Currently Displaying Inquiry Tracking Number: **279290**
[Basic KDB Search](#)
[Advanced KDB Search](#)
[Submit an Inquiry](#)
[Reply to an Inquiry Response](#)
[Category List](#)
[FAQ Search](#)
[Major Guidance Publications](#)
[Draft Laboratory Division Publications](#)
[Draft Laboratory Division Publications \(Expired\)](#)
[Draft Publication Moderation Policy](#)

Subject: PAG for KDB 680106 wireless charger

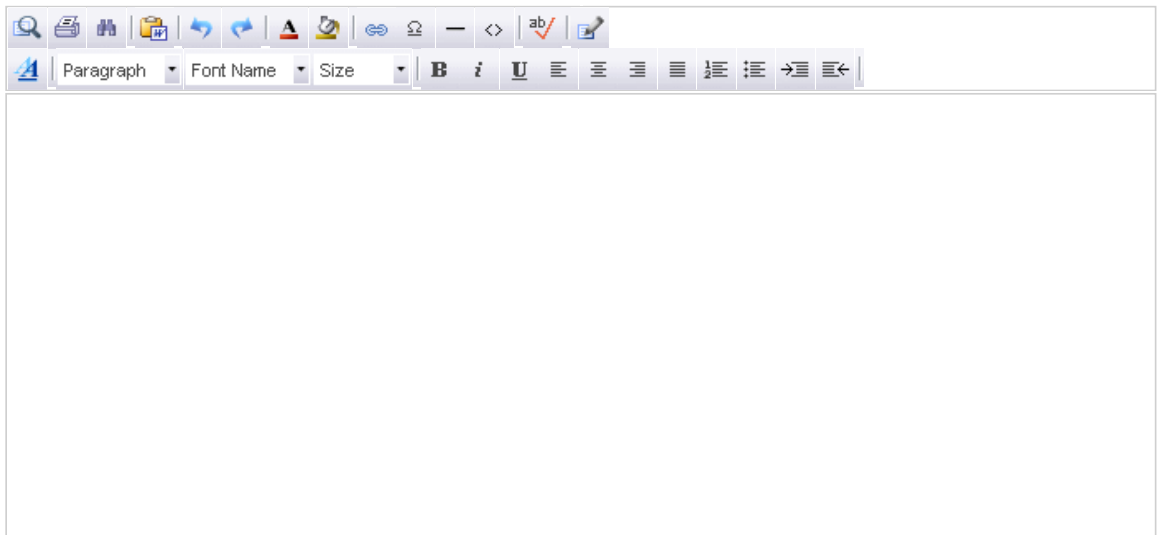
Yes, it is a portable device. We would like to apply for FCC ID and Updated Wireless Charger KDB 680106 Declaration 2.0, RF Exposure Evaluation 2.0. Help confirm whether it is OK, thanks.

Test plan is acceptable
